Report: TAB PUNCLIST
Function: Test, Adjust, & Balance
Date: 06/03/2025
Completed By: National TAB

**06-02-25 CAVA NORTH BRUNSWICK, NJ
(MAIN ST)**

Project: 06-02-25 CAVA NORTH BRUNSWICK, NJ (MAIN ST)

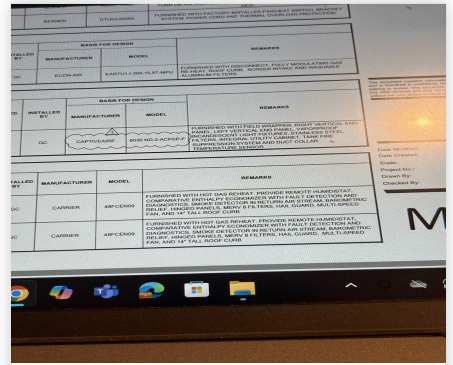
Issue Name : RTUs Missing hail guards
Description : See M400 RTU remarks section
Created By : National TAB **Assigned To :** National TAB - Tyler Youells
Status : Open
Priority : Low **Asset Tag :**
Originated Date : 06/03/2025 - Tyler Youells - National TAB
